SERVICE INSTRUCTIONS

REFERENCE: UPS-202301_B

SUBJECT: Smart Tachograph V2 Replacement for FMAX and Legacy Vehicles without ADR

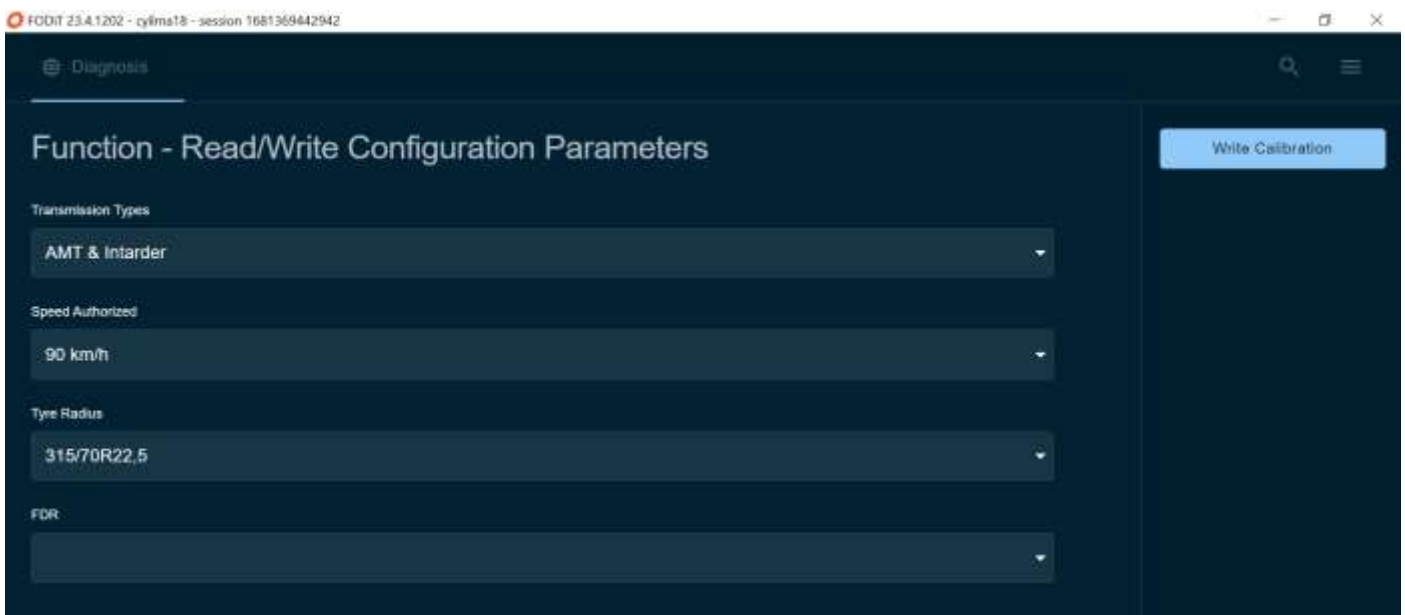
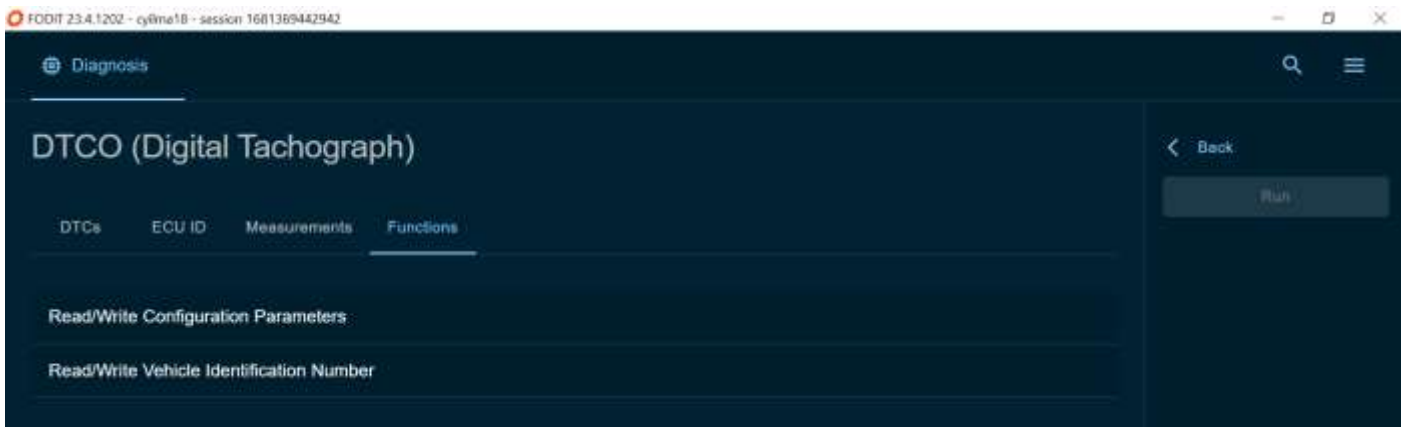
For replacement of the smart tachograph from DTCO 4.0 to DTCO 4.1 on FMAX and Legacy vehicles, the following changes must be applied:

- The old version DTCO 4.0 tachograph should be removed from its place with the help of tachograph rods.

- The electrical wiring connections and antenna wiring connectors should be unplugged from the DTCO 4.0 tachograph.

- The connections of the new version DTCO 4.1 tachograph are also compatible with the old version tachograph connectors that have been removed. The connectors and antenna wirings of DTCO 4.0 should be plugged to the DTCO 4.1 version Smart Tachograph.

- The vehicle must be connected with FODIT and the vehicle's configuration parameters and VIN information must be entered on the FODIT screen. The DTCs should be cleared then the DTCs should be read and ensure that there are no DTCs in the DTCO 4.1.
